# Joint Regional Planning Panel

<b>JRPP Number:</b>	2013SYE079
<b>DA Number:</b>	DA-2014/84
<b>Local Government Area:</b>	ROCKDALE
<b>Proposed Development:</b>	Integrated Development - Discovery Point - Construction of 19 storey residential flat building complex comprising Stages 8 - 10 and including 323 units, swimming pool, landscaping, basement parking, public domain works and associated road works and stratum subdivision
<b>Street Address:</b>	1 Princes Highway, Wolli Creek
<b>Applicant/Owner:</b>	Discovery Point Pty Ltd
<b>Number of Submissions:</b>	Nil
<b>Recommendation:</b>	Approval as a deferred commencement consent
<b>Report by:</b>	Marta M Gonzalez-Valdes – Coordinator Major Assessments

Figure 2 – Podium level showing location of private courtyards

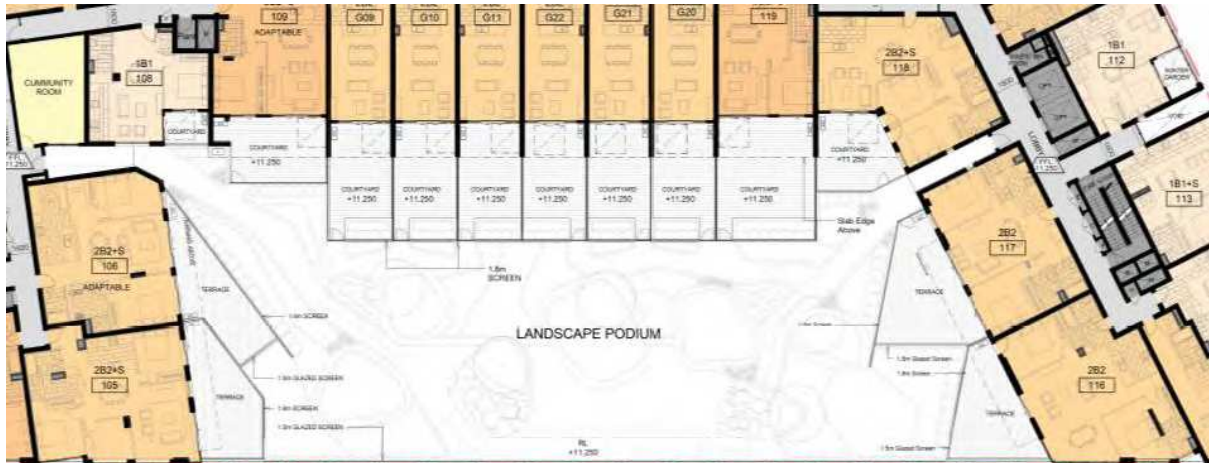
However, the size of the proposed communal area, significantly reduced by the private courtyards, remains an issue in my view. The approximate area of the podium is 725sq.m. as compared to a more generous area envisaged in the Concept Plan and Development Design Guidelines for Discovery Point. SEPP 65 and Council's Development Control Plan 2011 recommend a minimum communal area of 5sq.m. per apartment. The recommended area based on 323 apartments is in this case 1,615 sq.m. The argument provided by the applicant is supported for apartments located on the towers. However, the proposed courtyard area for apartments G09, G10, G11, G20-G22 and 119 (in the centre as shown in Figure 2 below) is considered to significantly reduce the usability of the communal area and as such they should be reduced.

The proposed courtyard area for the two bedroom apartments (all except 119) is approximately 30sq.m. The courtyard area for the 3 bedroom apartment (119) is 53sq.m. These areas are well in excess of the recommended area under SEPP 65 and DCP 2011 (16 and 24 sq.m. respectively). It is also noted that the two bedroom apartments have street access with an entry area of approximately 6sq.m.

A reduction to the area of the private courtyards by approximately 7sq.m. (excluding the planting area) to make the fence align with the courtyard fence in apartment 118 is not considered to significantly reduce the amenity of such apartments and would achieve an additional 110 sq.m. for communal use. The applicant argued that part of the area is covered by the balconies of the floor level above. However when excluding the covered area, the balconies still achieve the minimum private open space recommended in the Discovery Point Design Guidelines for two bedroom apartments (8sq.m.).

Based on the above, a condition of consent is proposed to ensure the courtyard area of apartments at podium level is reduced, in accordance with the intent of the Concept Plan, SEPP 65 and DCP 2011.
